10V-053
(3 Pages)

Re: Defect Information Report FL-572, Pitman Arm Installation

Defect Information Report

Restraining washer tabs shown aligned with notches in retainer prior to bending

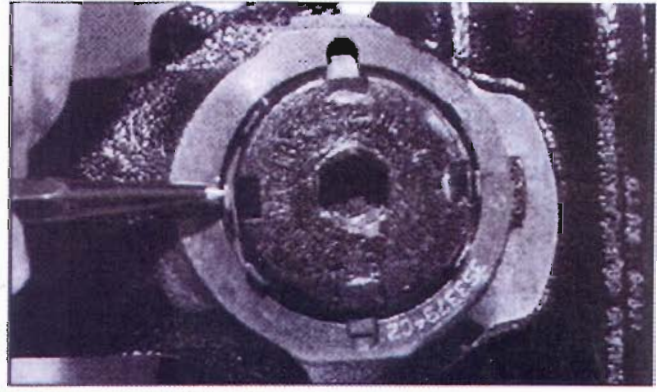
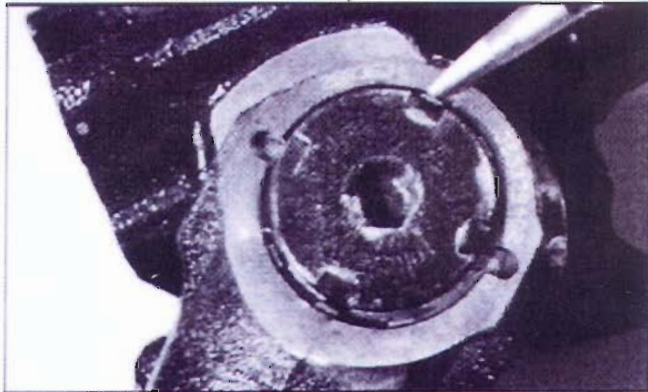
(c)(5) Description of the defect: Restraining washer locking tabs may not have been seated into the pitman arm retainer notches during assembly at the Saltillo plant.

49CFR Section 577.5(f) Evaluation of the risk to motor vehicle safety: Incomplete installation of the pitman arm retaining mechanism may allow unthreading of the retainer, and in the worst case, disengagement of pitman arm from the steering box resulting in loss of steering and crash.

- (c)(7) **Noncompliance-test or other data:** Not Applicable
- (c)(8) **(i) Remedial program:** Potentially affected vehicles will be inspected to insure pitman arm retainer is properly torqued and restraining washer is properly installed with locking tabs seated in notches of the retainer. Repairs will be performed by Daimler Trucks North America dealerships and Direct Warranty customers, i.e., customers approved by Daimler Trucks North America to do their own warranty repairs
Reimbursement Plan: Copies will be submitted as a supplemental report when available.
